October 24, 2023

Subject: Trumark at Kassis (PLND-0623-0073) Consistency Review per SB 330

DESIGN REVIEW LANDSCAPE PLAN CHECK
City of Rancho Cordova

Project: CE455_Trumark at Kassis TSM, DR PLND-0623-0073 - Rancho Cordova, California
Reviewed by: Michael Engle, RCLA 4672
Comments to: Arlene Granadosin-Jones, Senior Planner
City of Rancho Cordova
2729 Prospect Park Dr.
Rancho Cordova CA 95670
916-851-8846

Preliminary Landscape Plan - Overall Site

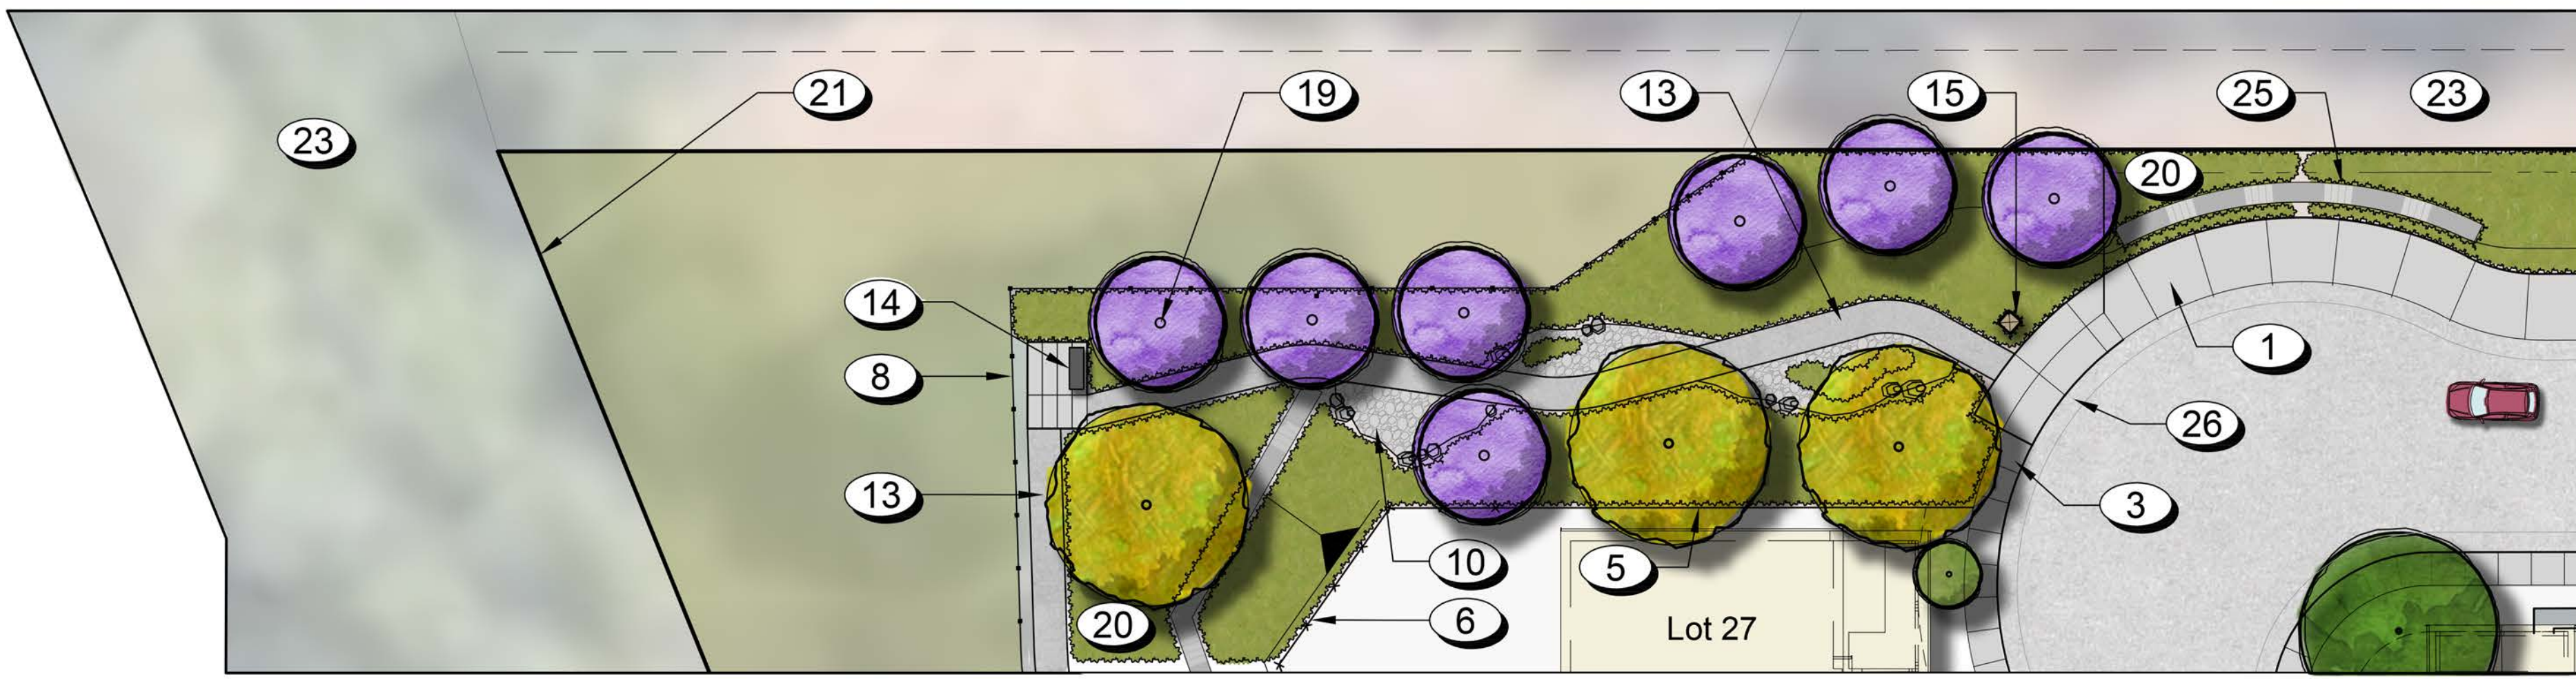
1. Sheet 1: Preliminary Landscape Plan – Overall Site
 - a. Provide preliminary parking lot shade calculations for common parking areas in the multi-family site.

- b. Provide preliminary MWELo calculations for the common area landscapes (Lots C, D, E, F, G and multi-family site), to demonstrate that project intends to comply with the water conservation ordinance. Include preliminary landscape areas in square feet.

- c. Provide generic irrigation statement that project intent is to comply with the state MWELo for water conservation. Include proposed irrigation method(s), automatic controller(s) and maintenance responsibility.

- d. Provide updated Tree Protection Plan. The previous application included an arborist report and Tree Protection Plan prepared by Live Oak Associates, dated 09/25/2020, which identified approximate clusters of existing trees located along and within the property line

that would be protected in place. Identify the protected clusters on the plan and/ or provide updated information on existing tree removals and protection.

Provide preliminary parking lot shade calculations for common parking areas in the multi-family site.

Provide preliminary MWELo calculations for the common area landscapes (Lots C, D, E, F, G and multi-family site), to demonstrate that project intends to comply with the water conservation ordinance. Include preliminary landscape areas in square feet.

Provide generic irrigation statement that project intent is to comply with the state MWELo for water conservation. Include proposed irrigation method(s), automatic controller(s) and maintenance responsibility.

Preliminary Landscape Plan - Lot E Neighborhood Green

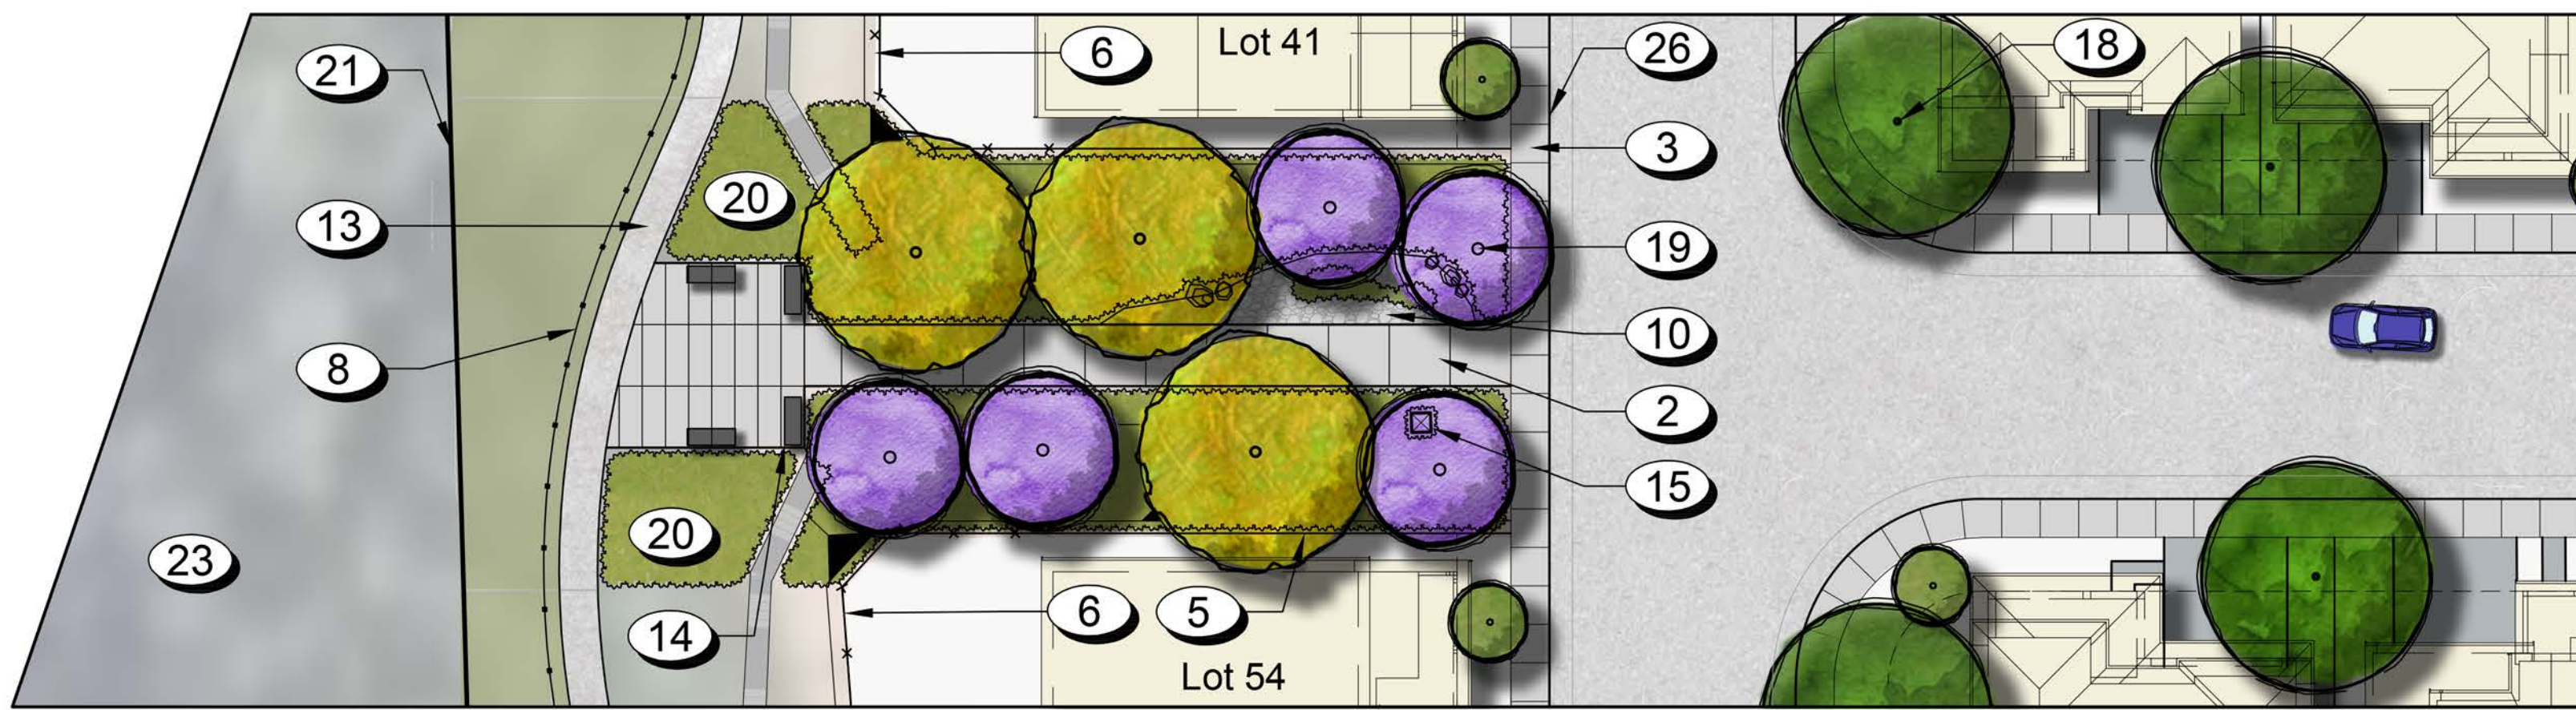
2. Sheet 4: Preliminary Landscape Plan – Lot E Neighborhood Green
 - a. Keynotes #8 & #9: The proposed post and cable fencing and the tubular steel fencing are difficult to distinguish from each other graphically on the plan. Revise for clarity.
 - b. Keynote #17: Consider a more permanent boundary, such as a concrete mowcurb, to separate the turf areas from adjacent landscaping.

- Consider more permanent boundary (concrete mowcurb)
- These 2 different fence types are difficult to distinguish on the plans.
